PCN-20190110a TE0820-03-* SPI Flash and eMMC Change

Company	Trenz Electronic GmbH
PCN Number	PCN-20190110a
Title	TE0820-03-* SPI Flash and eMMC Change
Subject	BOM change
Issue Date	2019-10-02

This change affects Trenz Electronic TE0820-03 SoMs: TE0820-03-*

old	new
N25Q512A11G1240E	MT25QU512ABB8E12-0SIT

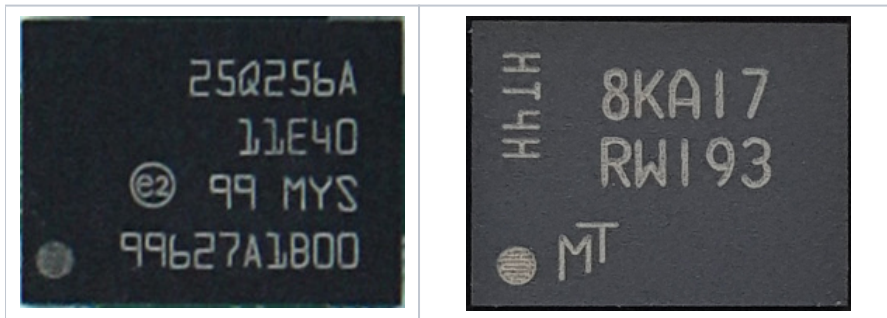
#1 Change SPI Flash from N25Q512A11G1240E to MT25QU512ABB8E12-0SIT

Reason: N25Q512A11G1240E became obsolete.

Impact: None. Both have same JEDEC ID BB20h and manufacturer ID 20h.

Locate Flash (U7, U17) on top side of PCB and eMMC (U6) on bottom side of PCB:

MTFC4GACAJCN-4M IT

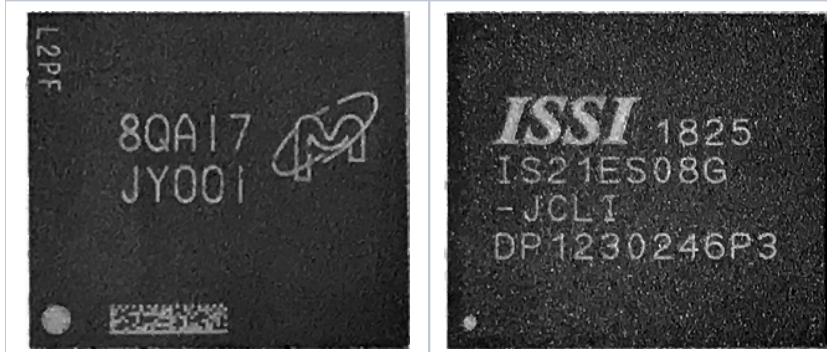
#2 Change eMMC from MTFC4GACAJCN-4M IT to IS21ES08G-JCLI

Reason: Improve availability.

Impact: The eMMC capacity changed from 4 GByte to 8 GByte.
